AGENDA
City of Salmon Arm
Development and Planning Services
Committee

SUBJECT: Development Variance Permit Application No. VP - 561 (Height of Retaining Wall and Fence and Principal Dwelling)
 Legal: Lot 1, Section 24, Township 20, Range 10, W6M, KDYD, Plan EPP119501
 Civic Address: 2794 25 Street NE
 Owners: James Weed and Elaine Crockrill
 Agent: Hindbo Construction (Coady Hindbo)

THAT: Development Variance Permit No. VP - 561 be authorized for issuance for Lot 1, Section 24, Township 20, Range 10, W6M, KDYD, Plan EPP119501 which will vary Zoning Bylaw No. 2303, as follows:

- i) Section 4.12.1 (a) Height of a combined retaining wall and fence from 2.0m to 6.9m and;**
- ii) Section 6.5 increasing the height of a principal building from 10.0m to 10.8m.**

PROPOSED RETAINING WALL HEIGHTS

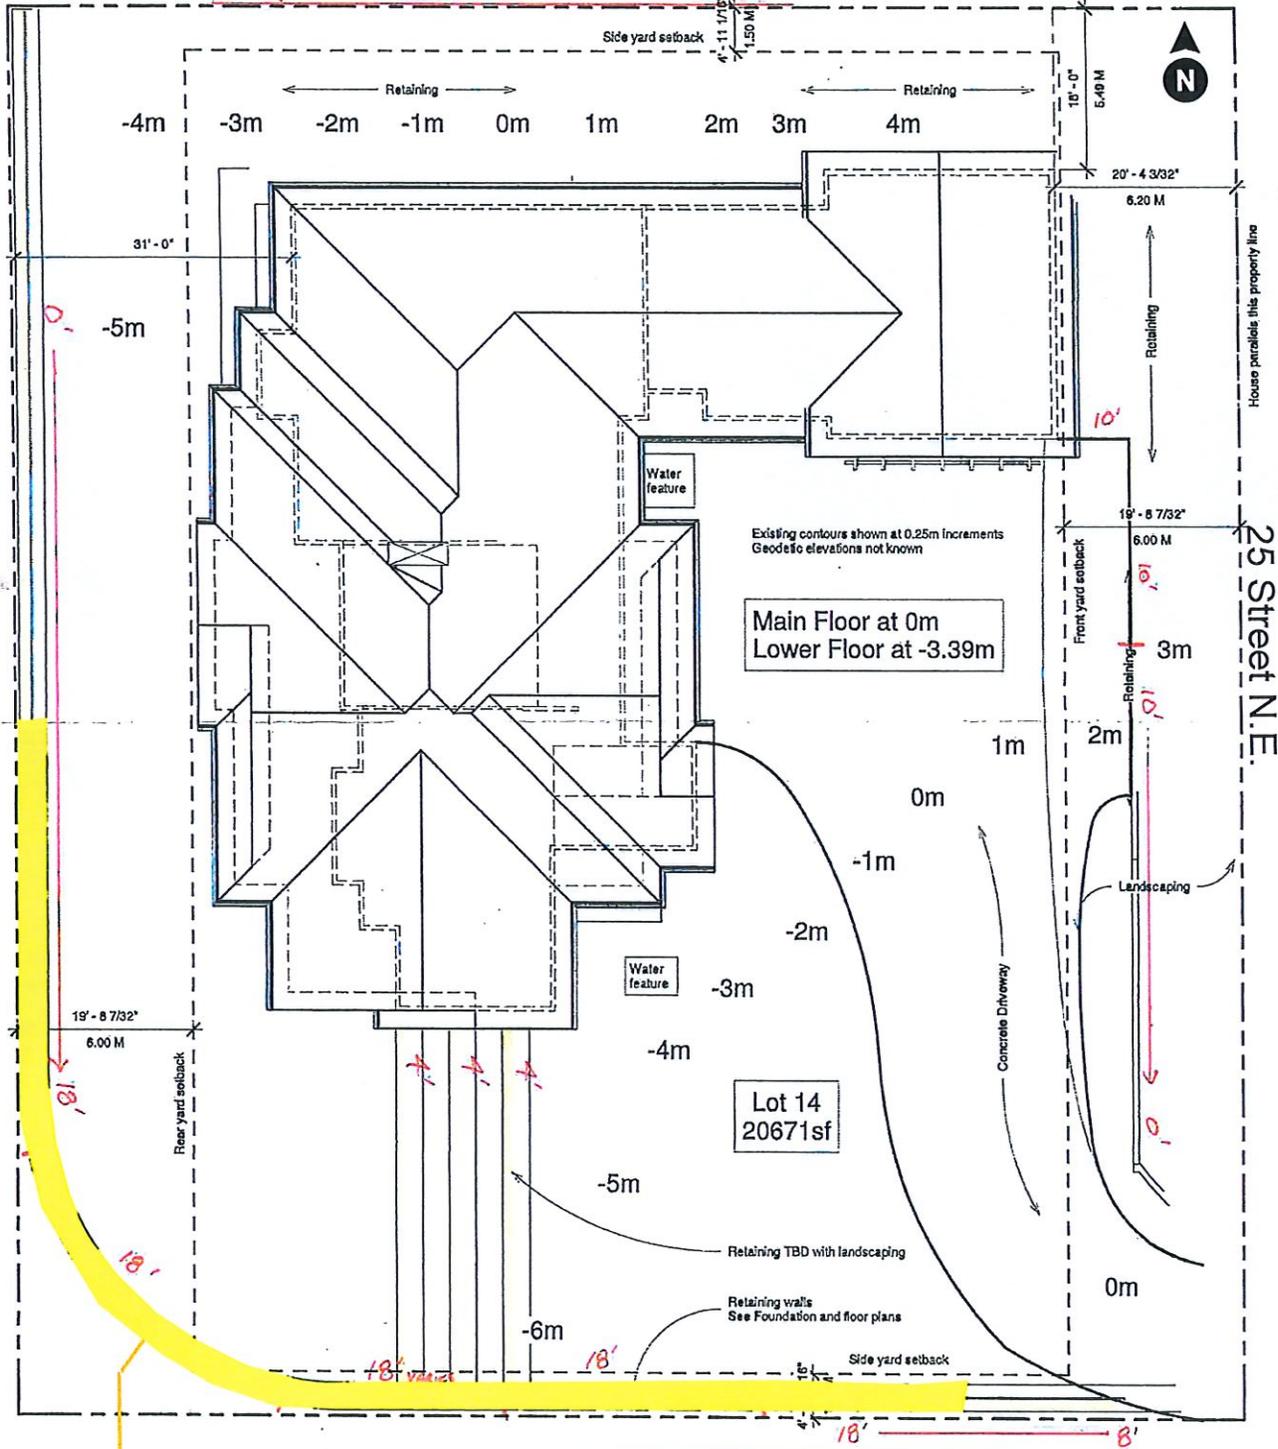
As shown in Appendix 1, the subject property is affected by steep slopes. The location of the proposed retaining wall and fence would affect the adjacent lot to the south. The impact of the proposed retaining wall and fence height are mitigated by the heavily treed area between the building area of the proposed house and the existing house on the south parcel, as well as, the topography of the lots. Staff do not see potential negative impacts along that section of the shared property lines. Staff note that the Zoning Bylaw governs the overall height of retaining walls but exempts the location of retaining walls in relation to the property line. To ensure that the wall can be maintained into the future, staff have asked that the applicant consider an easement over the adjacent property so that it may be constructed and accessed via adjacent lot without trespass. Given the height of the proposed retaining wall a Building Permit would be required prior to construction.

Variance Request: Combined Height of Retaining Wall and Fence from 2.0m to 6.9m

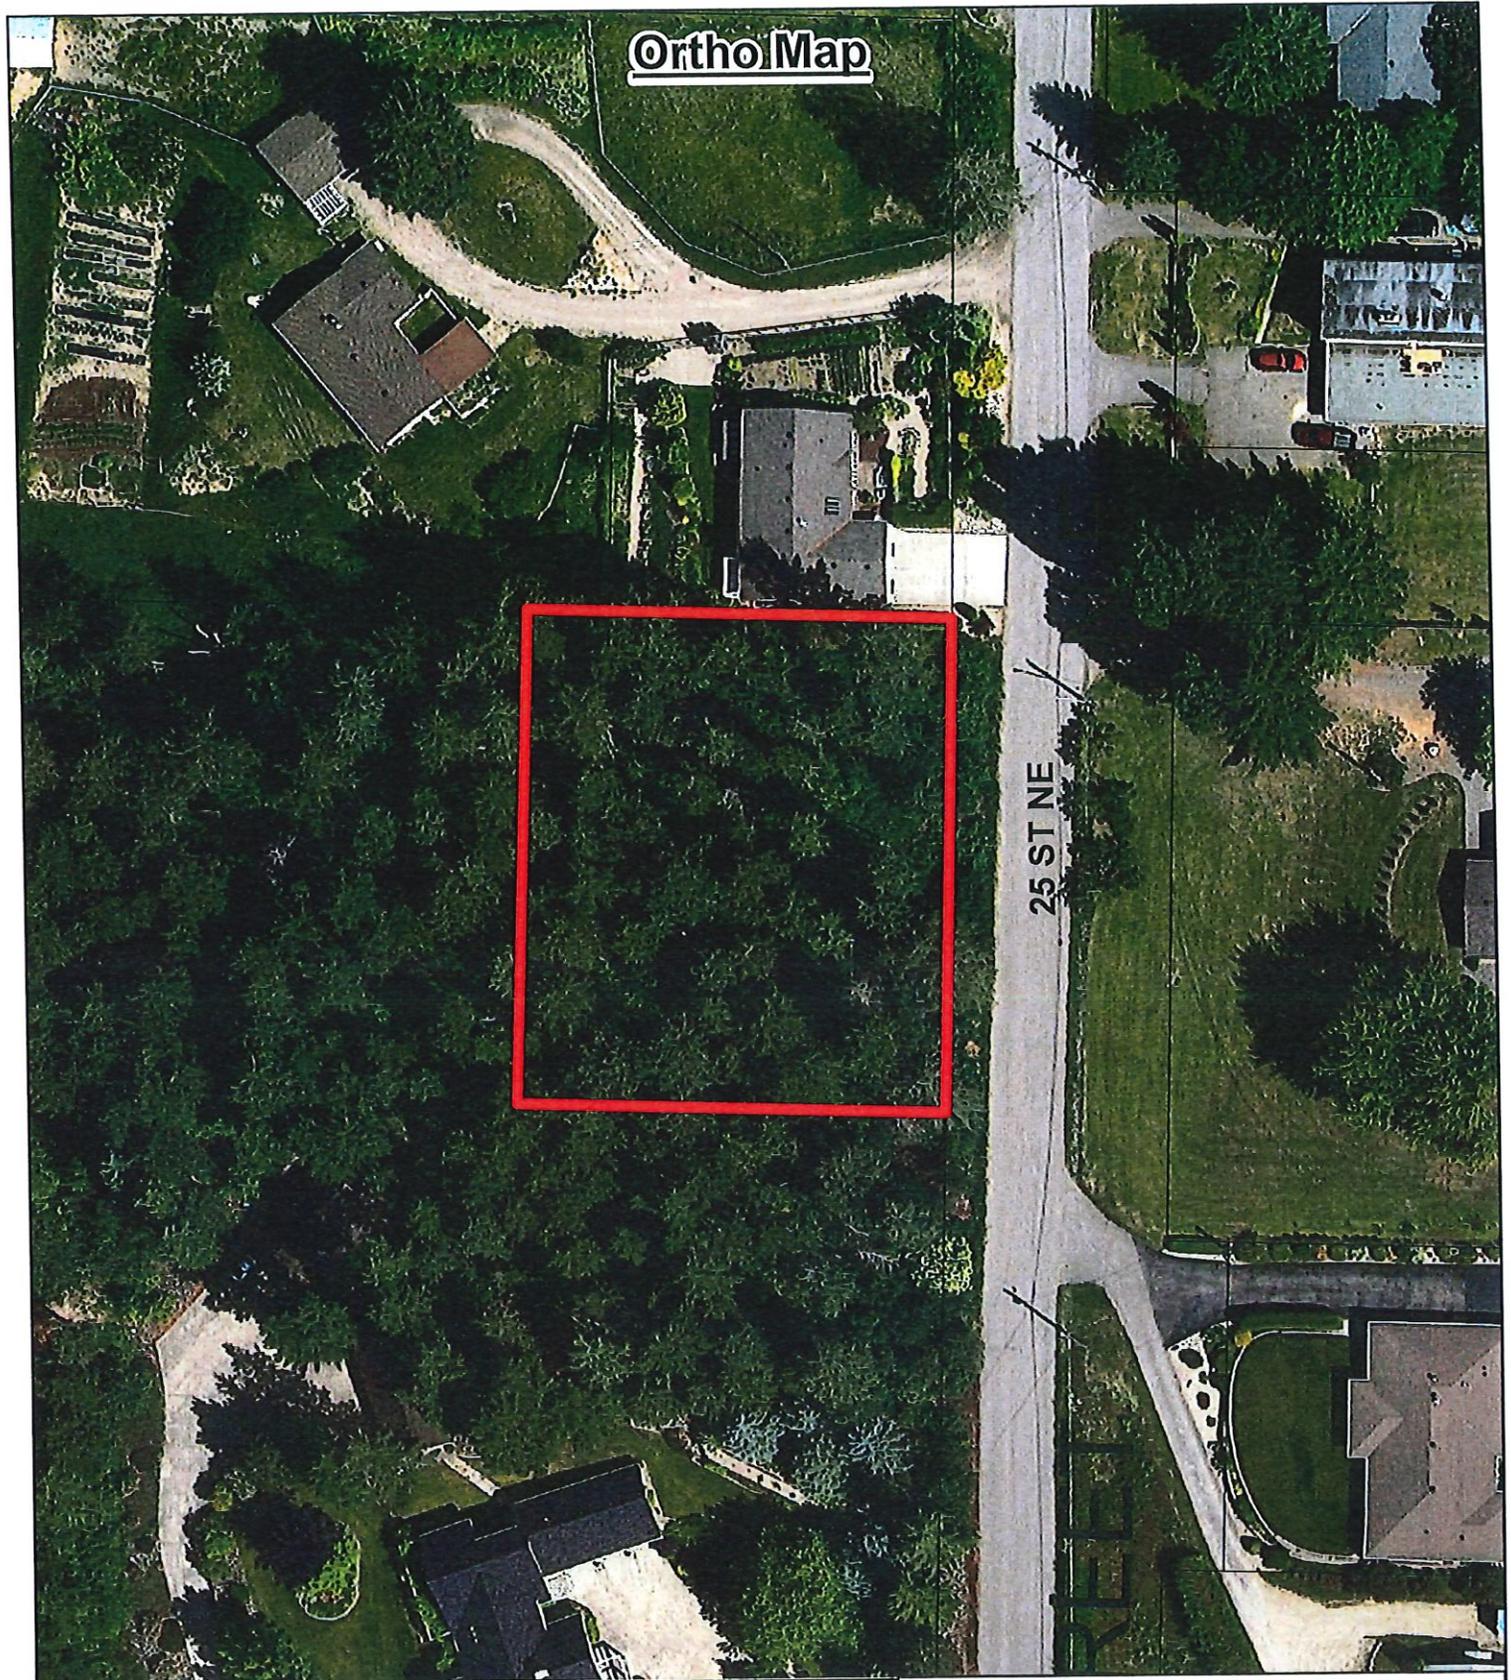
Current zoning rules state a variance is required if the roof height exceeds 10 meters (32' 9 11/16") and a retaining wall exceeds 2.0 meters (6.5ft.). We respectfully request a roof height of 10.74 meters (35' 3") and a retaining wall height up to 5.5 meters (18').

Due to the grade/slope at 2791 25th Street NE (the property) where the proposed single-family residence will be built, we feel the extra .74 meters of roof height will not negatively affect views while traveling on 25th Street NE. In fact, with the trees removed to create a building site for the house, the view should be enhanced.

Due to the grade/slope of the property, we require several retaining walls. One of which, below the house will vary from 0 to 18' in height. Another retaining wall, adjacent to the garage will be from 0 - 10' in height. The balance of retaining walls do not require a variance.
